ECN/PCN No.: M1710

Product Description: RJ45 10/100 Base-T Jack with Magnetic Module	Abracon Part Number / Part Series: ARJ11B Series	<input type="checkbox"/> Documentation only <input checked="" type="checkbox"/> ECN <input type="checkbox"/> EOL	<input checked="" type="checkbox"/> Series <input type="checkbox"/> Part Number(s)
Affected Revision: B	New Revision: C	Application:	<input type="checkbox"/> Safety <input checked="" type="checkbox"/> Non-Safety

Before Change:

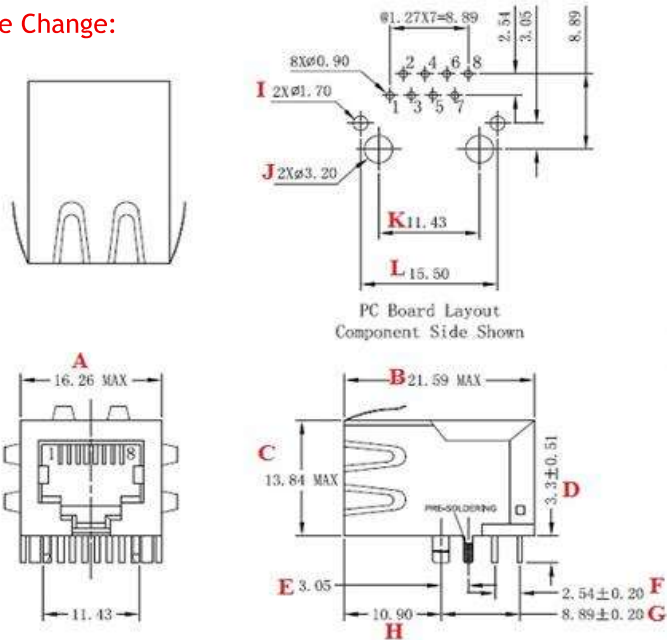
Prior to Change:
 Update housing details for ARJ11B-MA

After Change:
 There is some variation in the mechanical Dimentions and Housing look and no change in the electrical characteristics

Before Change	After Change
D	3.3±0.51	3.5
H	10.9	10.7
I	1.7	1.6
J	3.2	3.25
K	11.43	11.43
L	15.5	15.7

After Change:

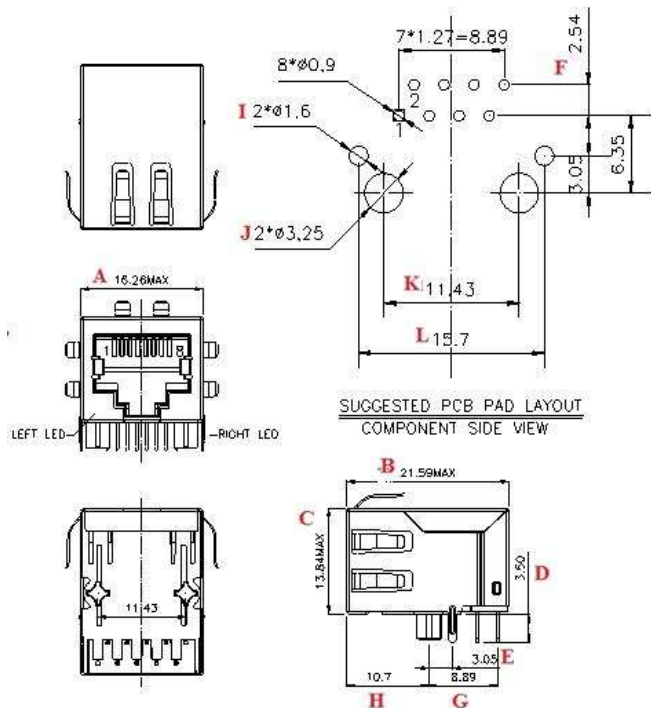
Cause/Reason for Change: New molding was added because the old molding was getting aged		
Change Plan		
Effective Date: 04/07/2026	Additional Remarks:	
Change Declaration: Change in the housing look and Mechanical Dimentions and no change in the electrical aspects		
Issued Date: 04/07/2026	Issued By: <i>Baji suryadevara</i>	Issued Department: Engineering
Approval: <i>Gerald Capwell</i> Director of Engineering (P & M)	Approval: <i>Reuben Quintanilla</i> Quality Director	Approval: <i>Ying Huang</i> Purchasing Director
For Abracon EOL only		
Last Time Buy (if applicable):		Alternate Part Number / Part Series:
Additional Approval:	Additional Approval:	Additional Approval:
Customer Approval (If Applicable)		
Qualification Status: <input type="checkbox"/> Approved <input type="checkbox"/> Not accepted <i>Note: It is considered approved if there is no feedback from the customer 1 month after ECN/PCN is released.</i>
